Community Input Recap

### Community Meeting #2

Held via Zoom on May 12, 2022 with **20 participants**

### **Concept 1: Most Pond, Least Program**

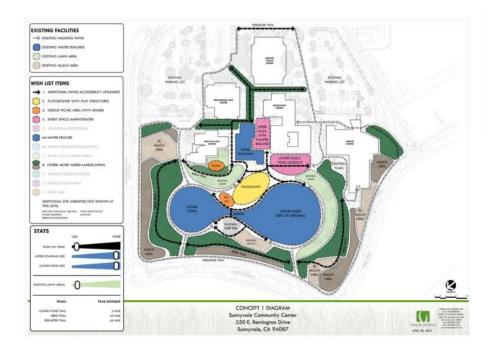
- · Additional trails on the berm
- · Additional picnic areas
- · Less program/ closer to the existing program
- Keeping the upper fountain and the sound of water falling to the lower pond

- · The addition of too much programming
- The large pond still takes up a large amount of space, doesn't help the bird situation, and requires a lot of maintenance
- · The dog park is not needed

- · More walking paths in the central area
- · Active recreation for adults
- Restrooms
- · Picnic areas under trees

### **Concept 2: Balance of Pond and Program**

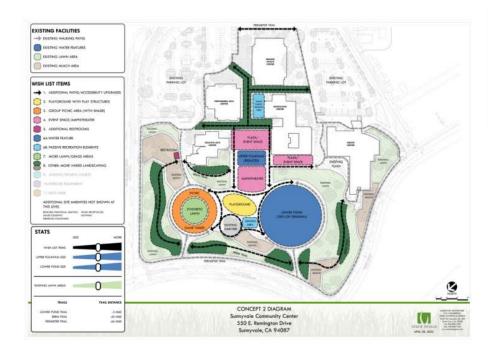
- The location of the amphitheater below the upper fountain and built into the slope
- · Restroom location away from central area
- · Trails on the berms
- · Large picnic area

- · Concerns about amphitheater noise
- · Still too much lawn
- · Still too much water
- · Restroom is too far from the central area
- · Concerns about synthetic turf

- Basketball court
- · Exercise stations
- Cascading water
- · More shade

### Concept 3: No Pond, Most Program

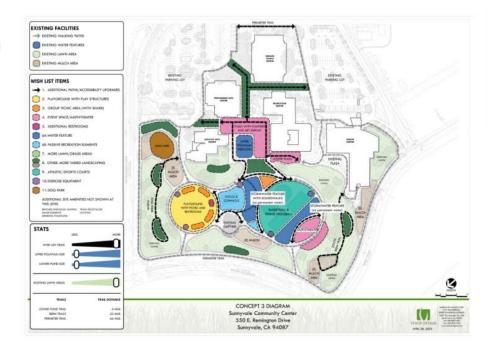
- The location of the amphitheater off Remington Dr and built into the hillside
- The reduction of the water features and inclusion of a seasonal stormwater feature
- Berm trail
- · Multiple picnic areas

- The concept feels too busy/ too much program
- · The dog park is not needed
- · Too much lawn
- · Not the right location for athletics
- · Completely removing the lower pond

- · More native landscaping in lawn areas
- Shade and seating in the plaza
